Tennessee Valley Authority, 1101 Market Street, Chattanooga, Tennessee 37402

CNL-14-164

September 18, 2014

**Subject: WATTS BAR NUCLEAR PLANT (WBN) UNIT 2 - TRANSMITTAL OF
UNIT 1/UNIT 2 AS-CONSTRUCTED FIRE PROTECTION REPORT
(TAC NO. ME3091)**

**FIGURE III-1
INTERACTION ANALYSIS FLOW CHART**

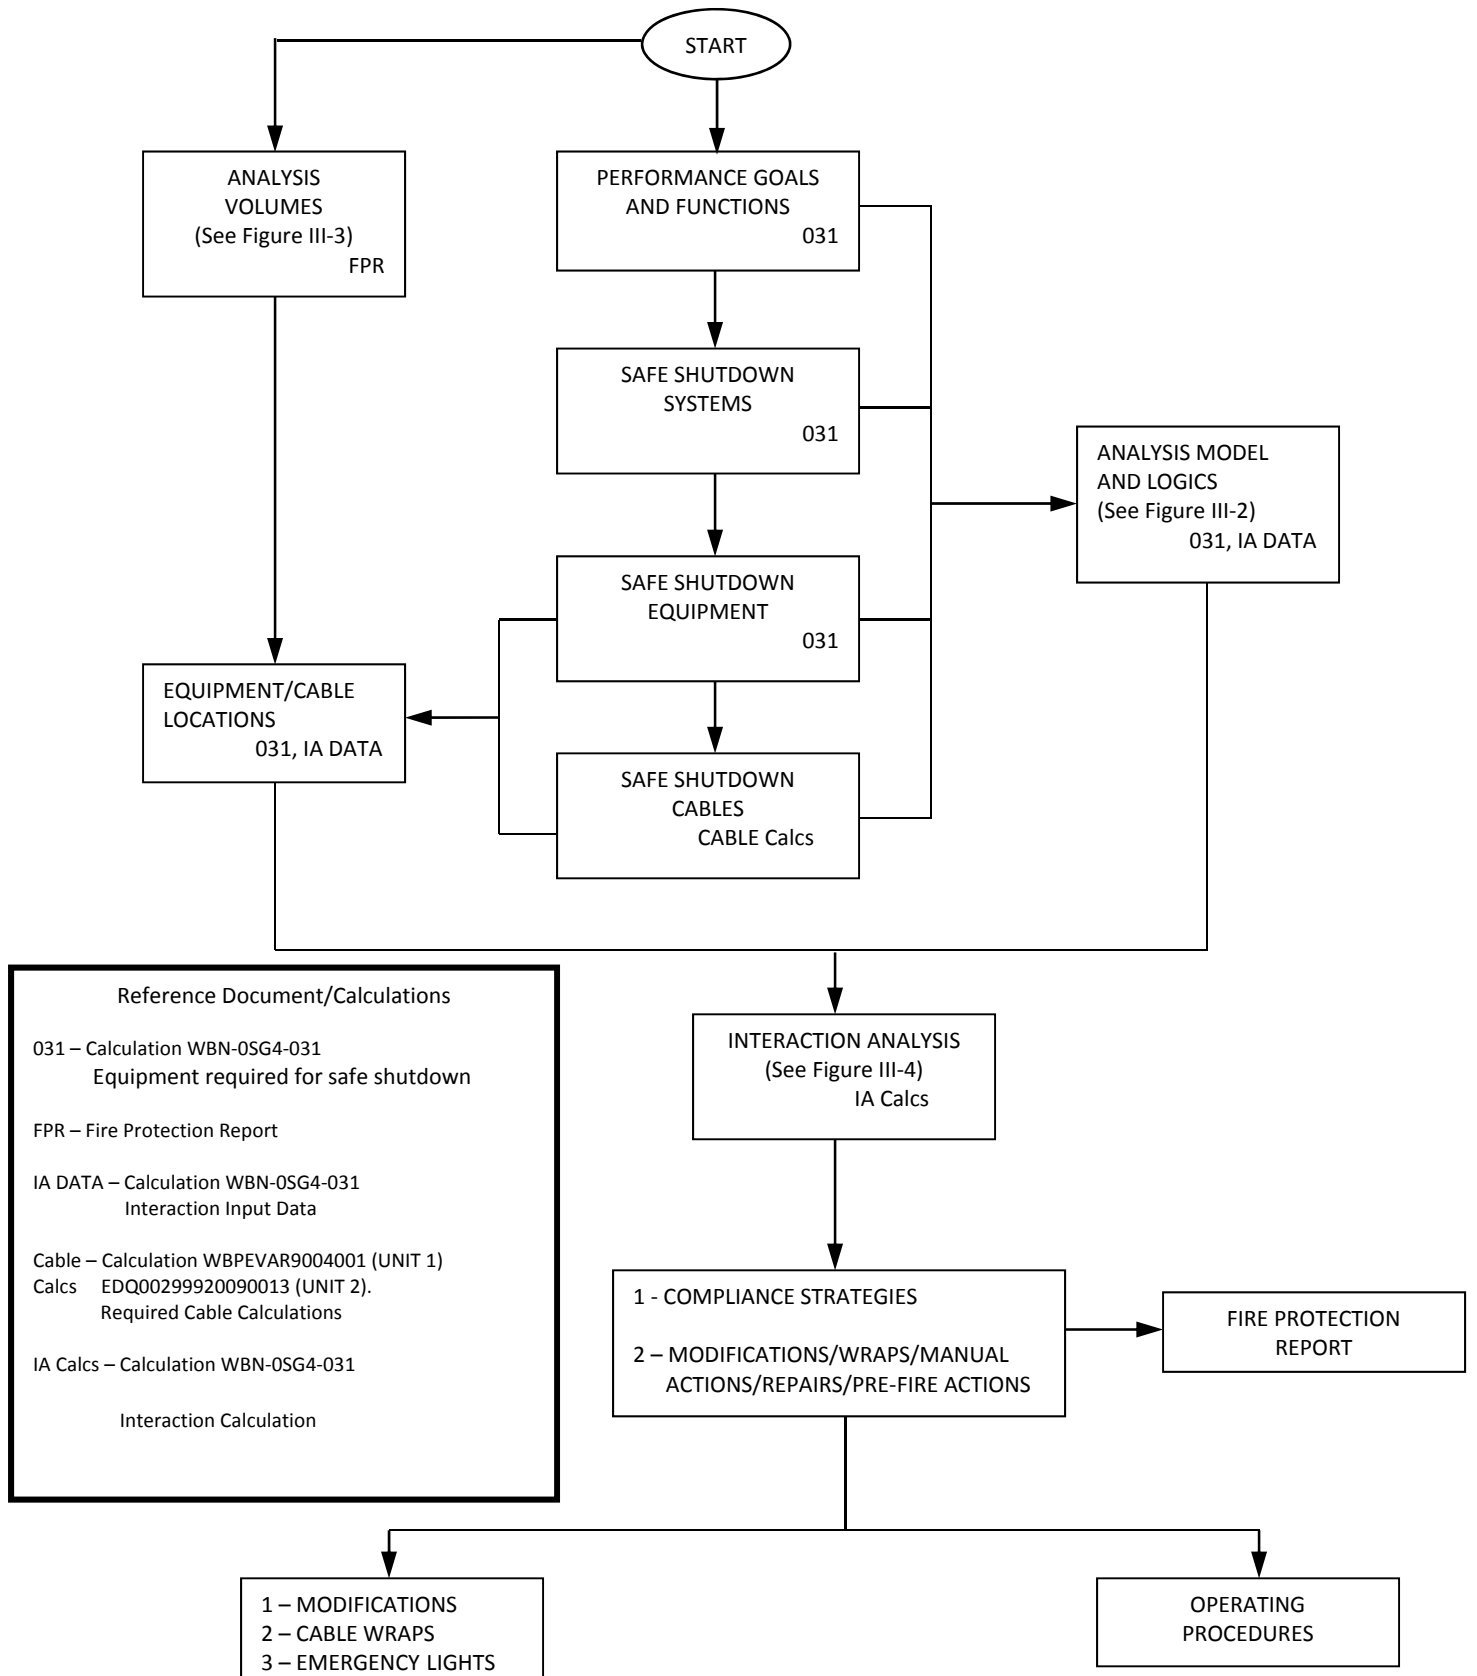
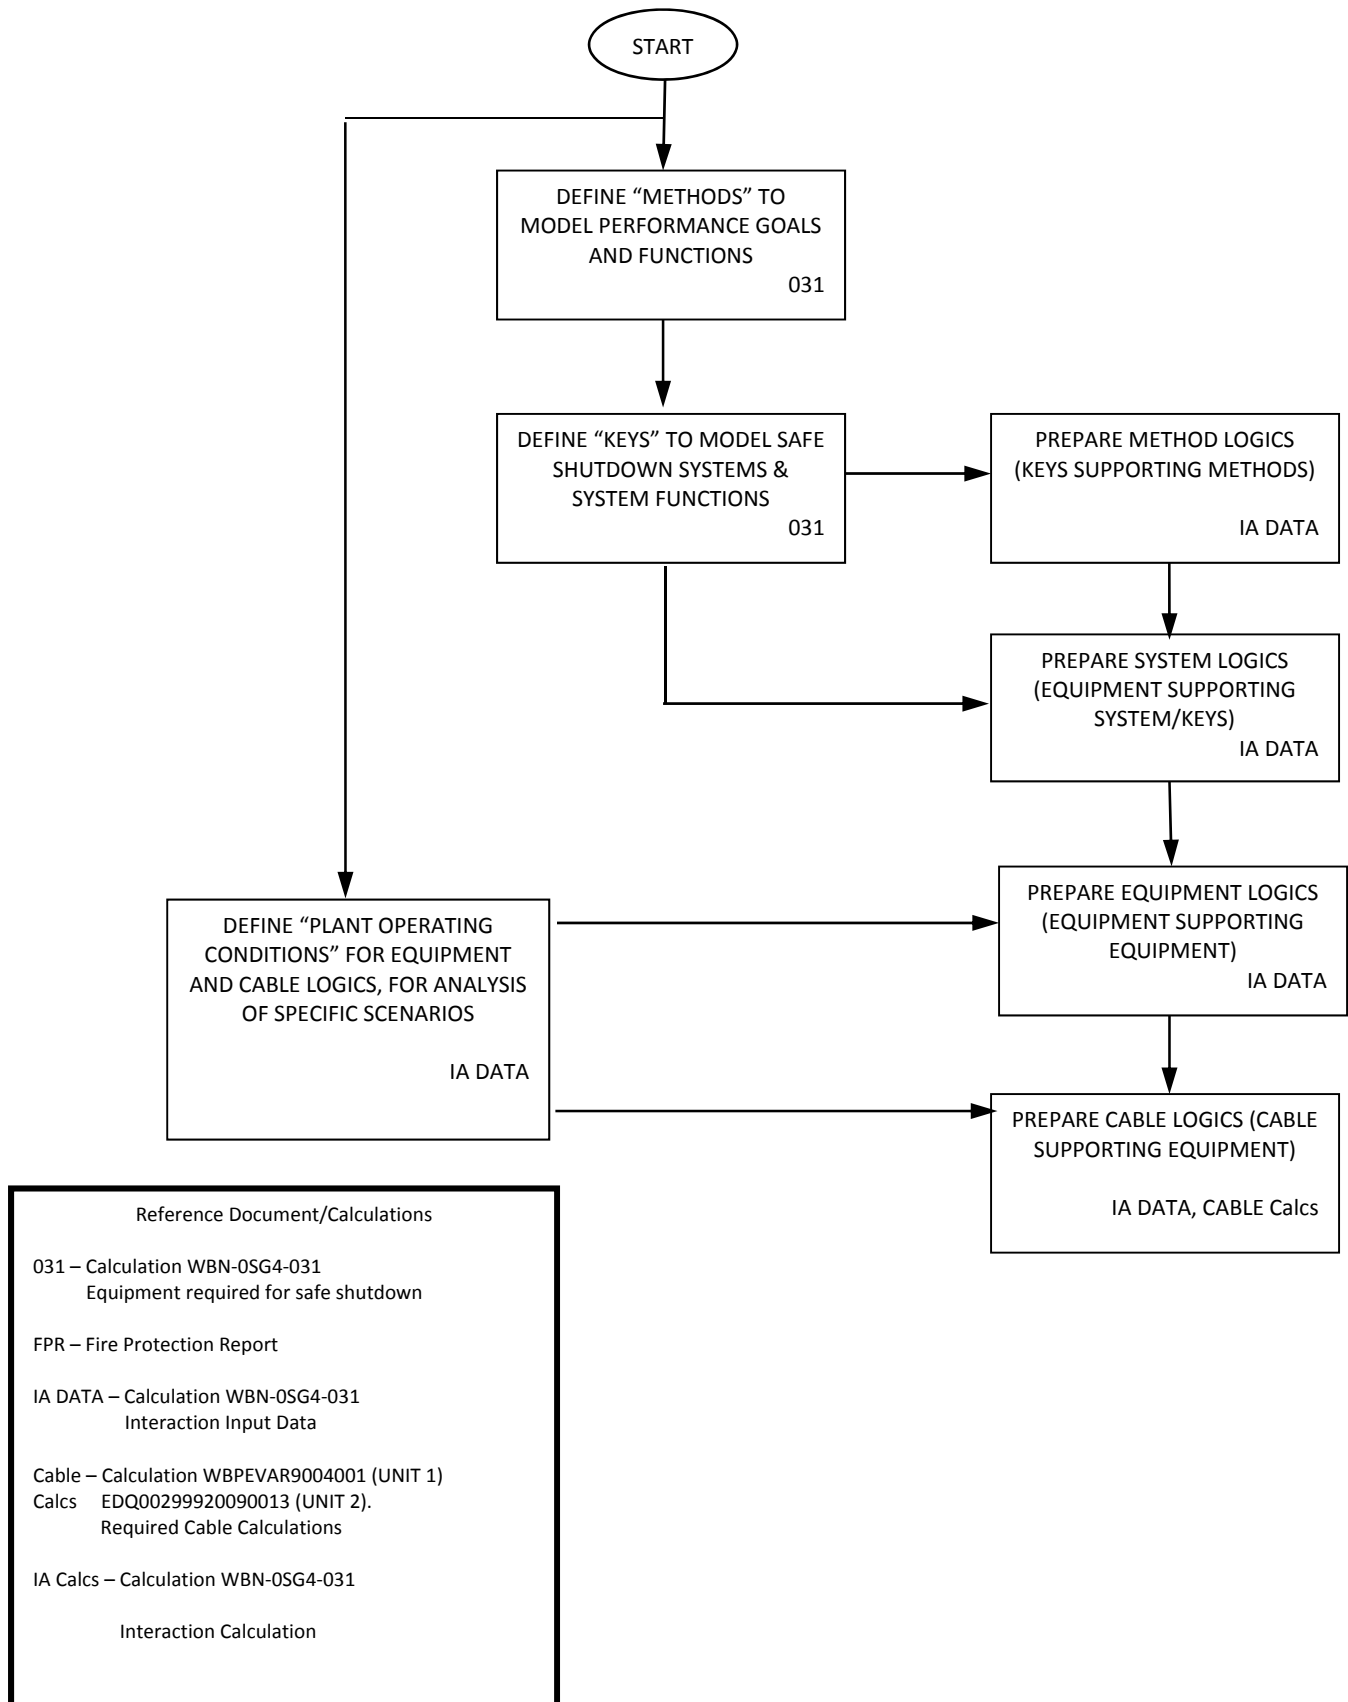
7. Part III, Figures III-1 and III-2
 Revised the number of calculation EDQ00099920090012 to be WBN-OSG4-031 for consistency with Unit 1 FPR.
8. Part III, Table 3-2, "Safe-Shutdown Equipment List"
 Updated information related to the nitrogen supply to PCV-1-5, -12, -23 & -30 and to LCV-3-172, -173, -174 & -175.
